BRYAN G HALL

Project Name:	Dearne Valley Parkway, Barnsley				
Client:	Gregory Property Group (GPG)				
Subject:	Response to Barnsley Highways Consultation Comments				
BGH Reference:	20-262-004.02				
Date:	05/09/2022				
Prepared by:	R. Donaldson	Checked by:	A. Bradley	Overview by:	M. Crabtree

Responses to BMBC August 2022 Consultation Comments

Drawing No: 20/262/TR/001

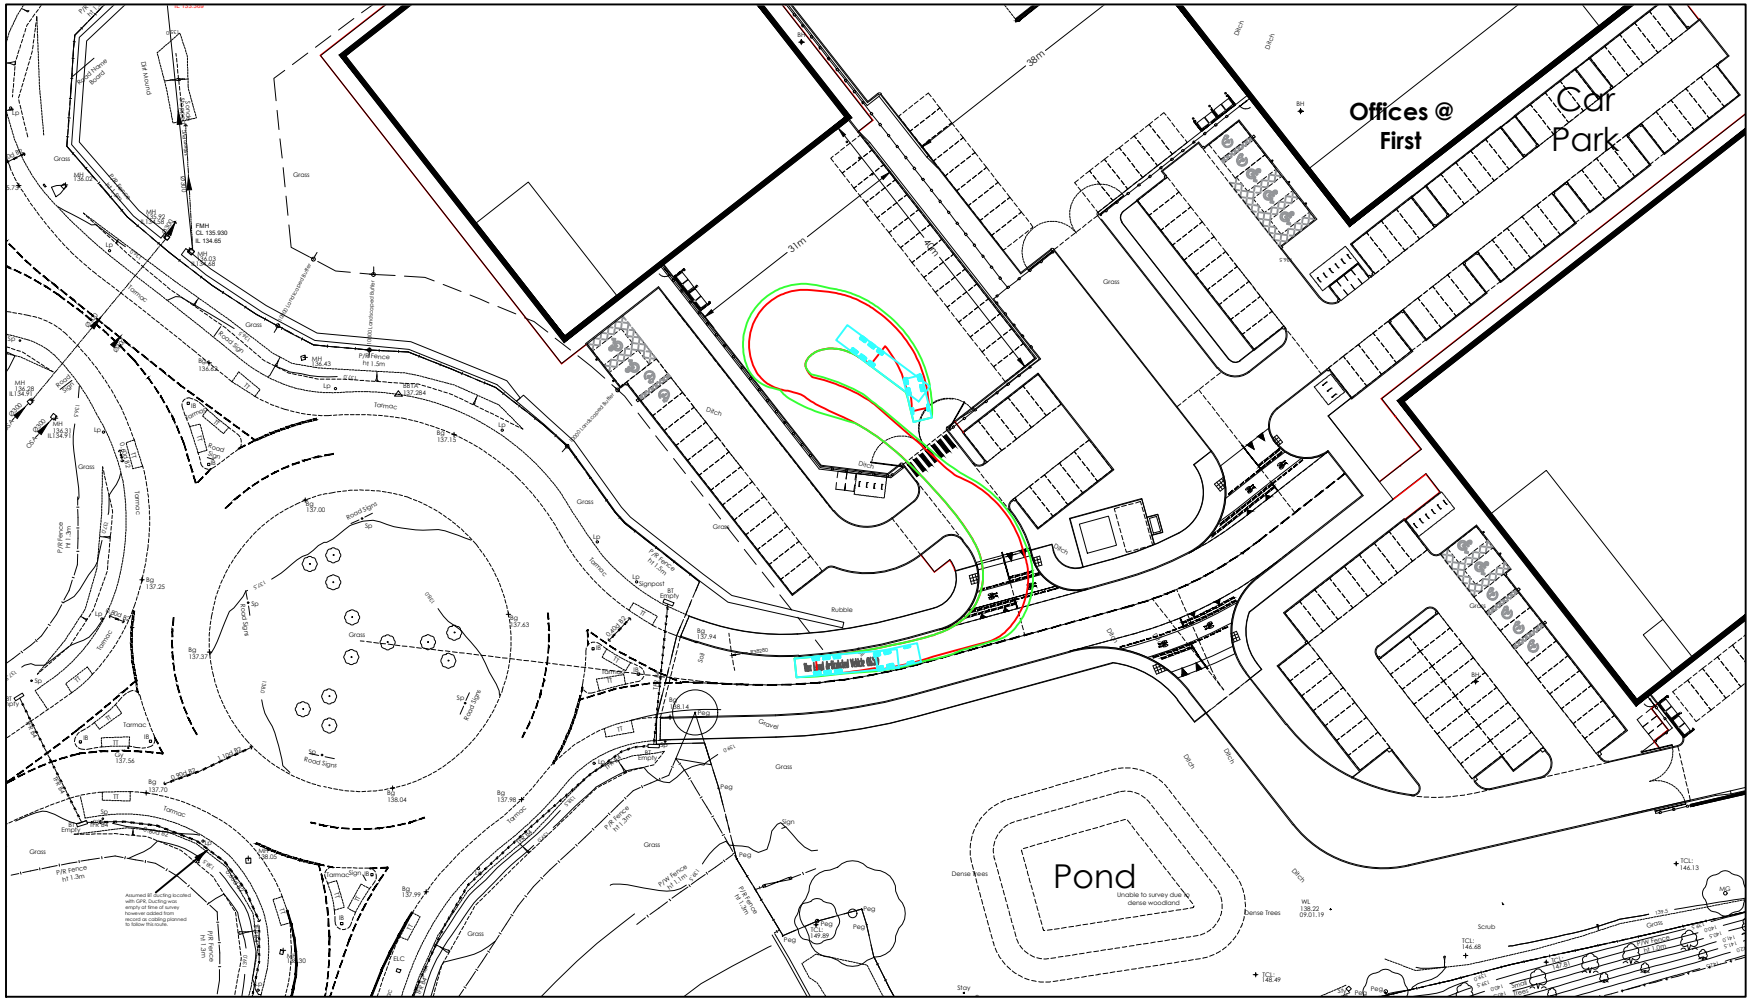
"The Transport Assessment appendix BGH 9 provides swept path analysis but will not be acceptable. A revised swept path analysis will be required that shows 2 x 16.5m articulated HGVs passing which should include a turning head."

7. Updated swept path analysis of the revised proposed site layout has been undertaken, which shows that a 16.5m articulated HGV can access the site and pass another HGV on the main site access road and the access road to Unit 3. The swept path analysis has been undertaken based on the proposed site layout with additional parking in the service yards, to demonstrate that there is sufficient room in the service yards for HGVs to manoeuvre with the additional parking in place. This is included at **Appendix BGH3** and can be summarised as follows:

- 20/262/TR/001 Rev C – swept path analysis of a 16.5m articulated HGV accessing and egressing the site using the existing roundabout junction with Sheffield Road;
- 20/262/TR/002 Rev C – shows that 16.5m articulated HGVs can access and egress each of the proposed plots;
- 20/262/TR/003 Rev B – shows that two 16.5m articulated HGVs can pass on the proposed Unit 3 access road;
- 20/262/TR/004 Rev B – shows that a 16.5m articulated HGV can manoeuvre within the proposed Unit 3 service yard;
- 20/262/TR/005 Rev B – shows that a 16.5m articulated HGV can manoeuvre within the proposed Unit 2 service yard;
- 20/262/TR/006 Rev B – shows that a 16.5m articulated HGV can manoeuvre within the proposed Unit 1 service yard; and
- 20/262/TR/007 Rev A – shows that two 16.5m articulated HGVs can pass each other on the main access road through the site.
